**Spanish City Link Road
Planning Application No. 10/01335/LAREG3**

In this letter I raise objections to the proposed link road through the Spanish City development site that is the subject of the “Stage 1 Developer’s Pack” issued by the Council in October 2009.

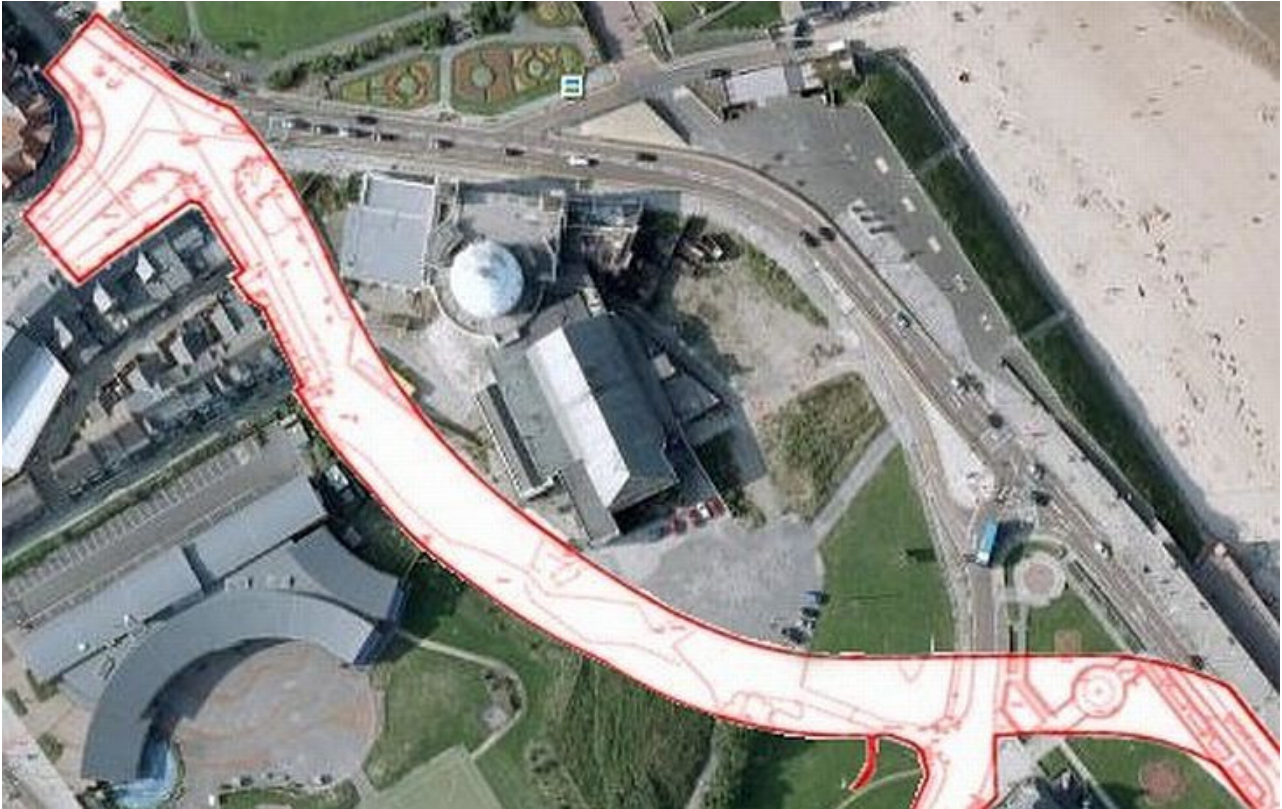
As shown in the following figure, extracted from the associated planning application document, ‘Location Plan’ (OS Extract – 204681.pdf) the proposed link road bisects the development site, passes close by the Marine Park First School and cuts through Brook Street Gardens.

One result of this proposal is the removal of a large area from the development site that, among other disadvantages, places a significant constraint upon prospective developers' proposals.
